# **DRAINAGE LETTER FOR WIDEFIELD COMMUNITY BIBLE CHURCH ADDITION**

**PCD File No. PPR2438**

October 2024

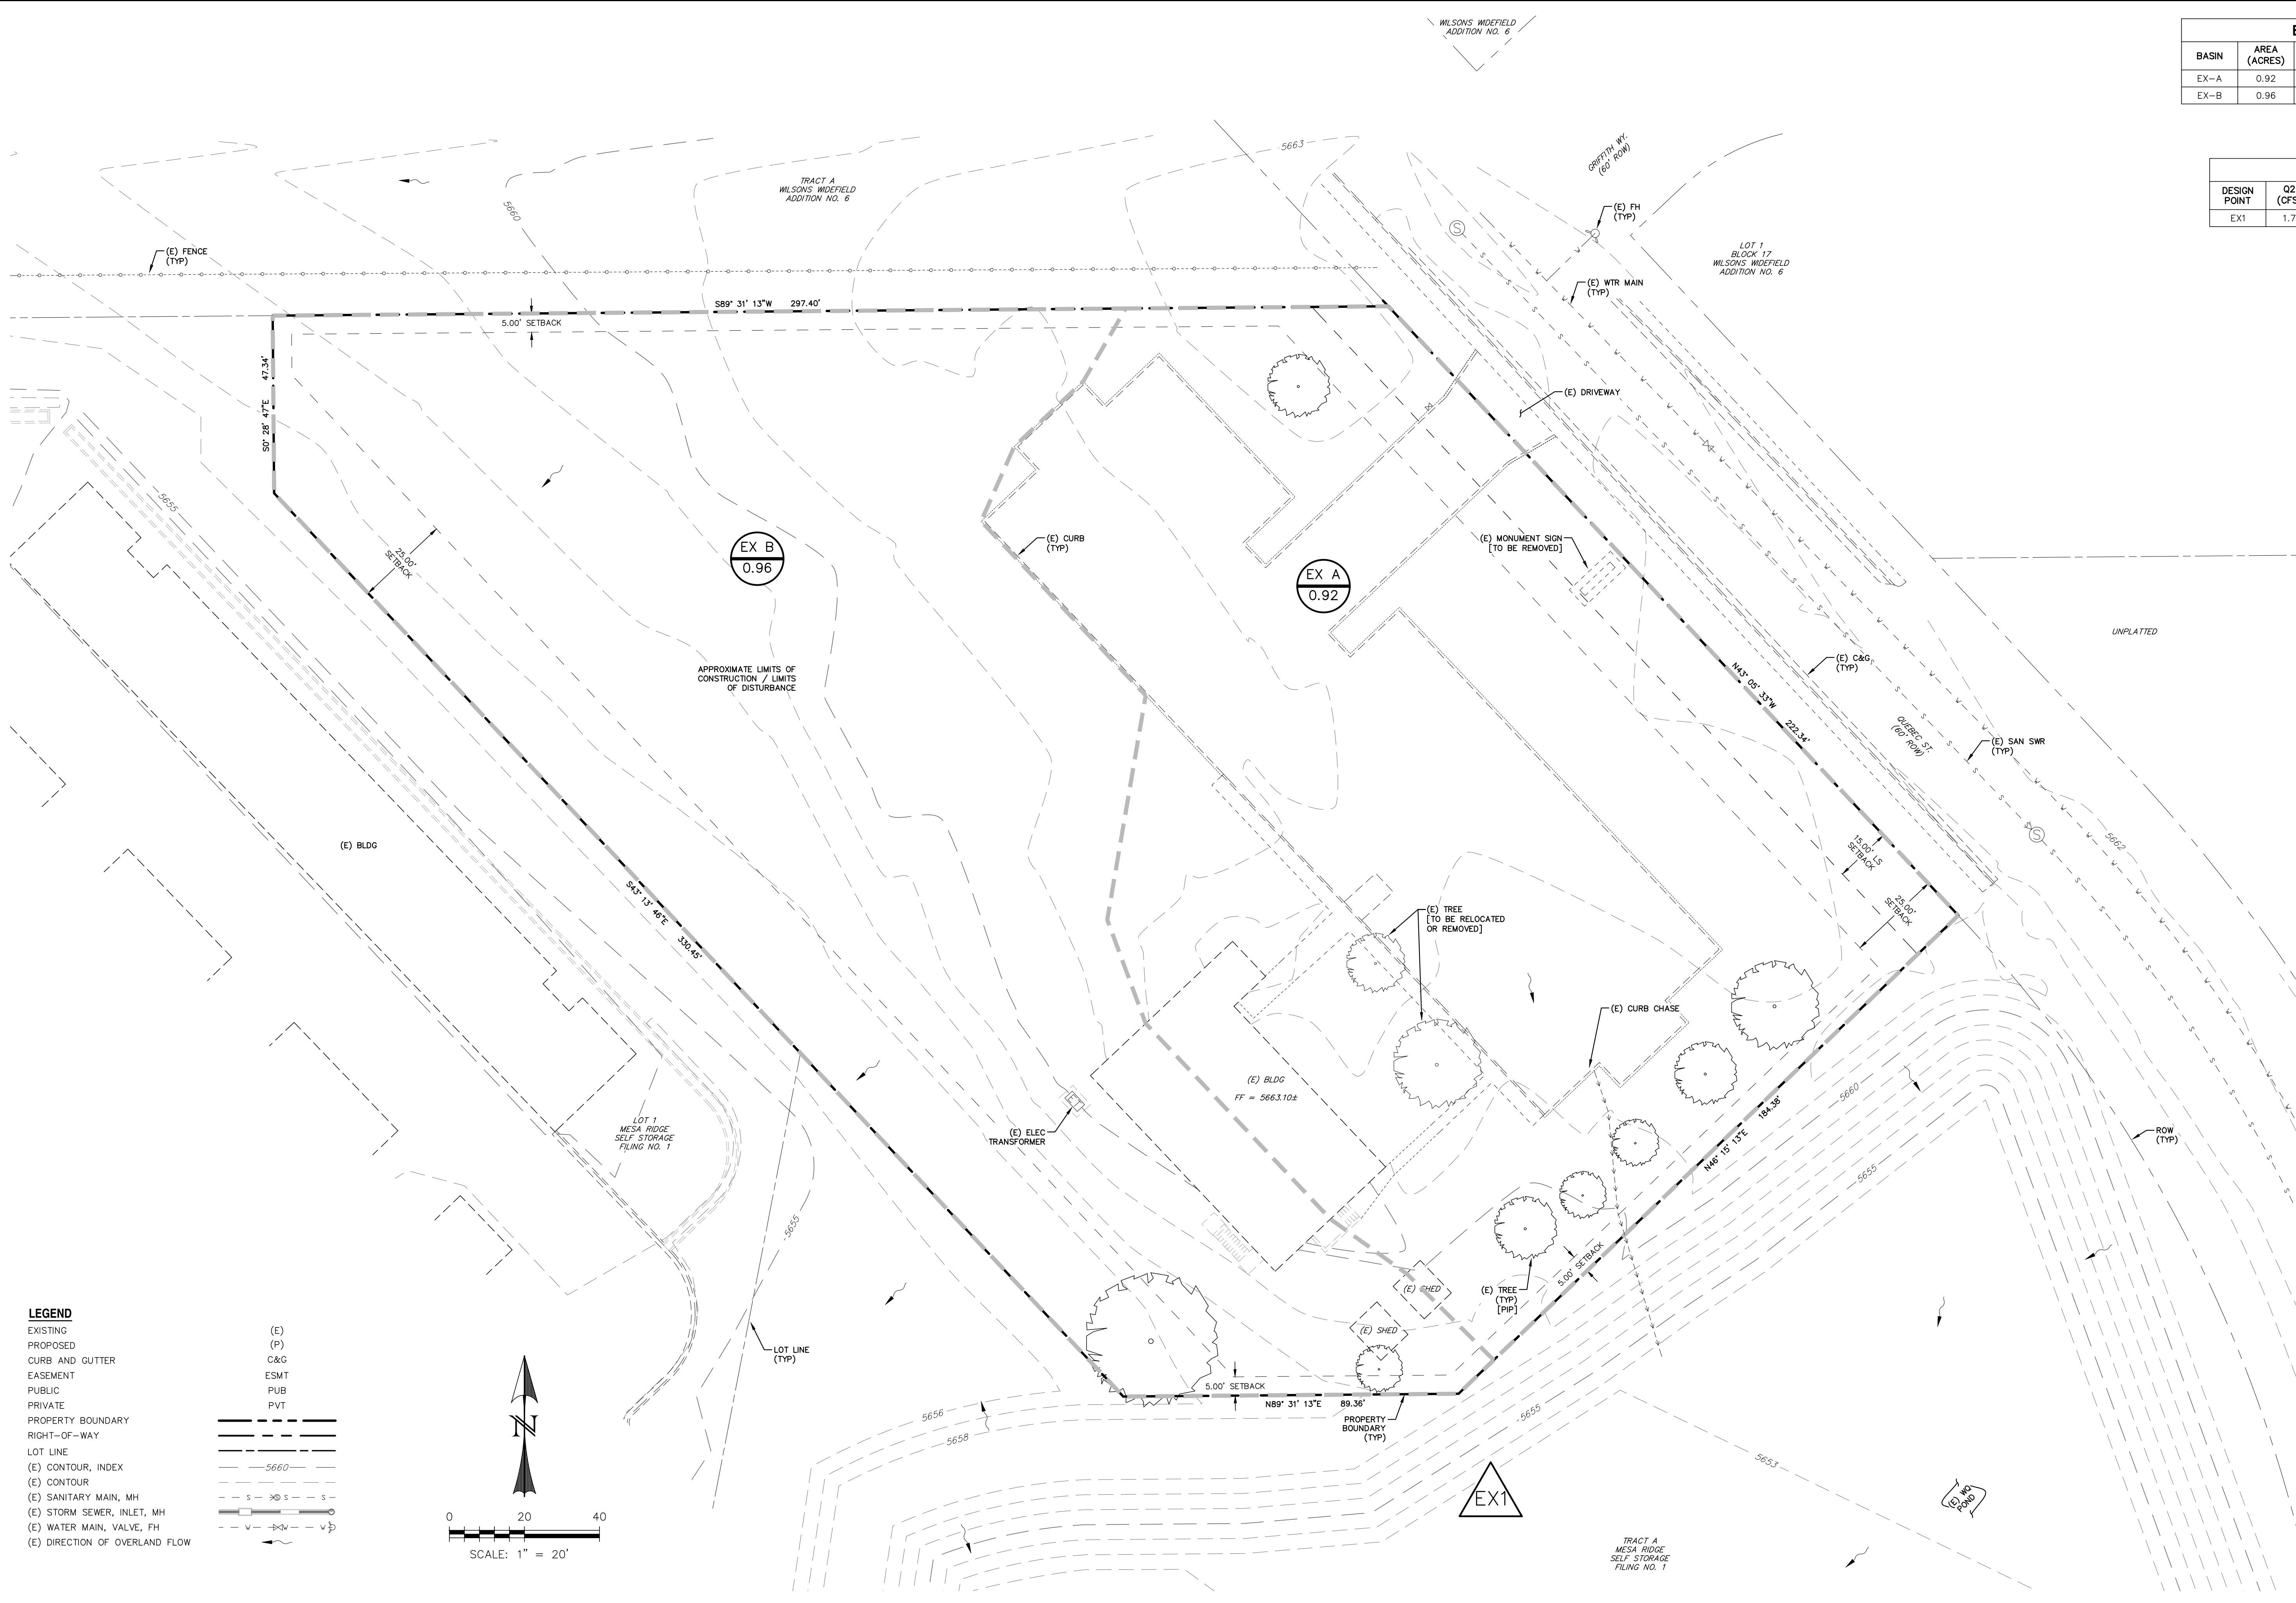
Please change the weighting on the basin line work

Include riprap design calculations in the report
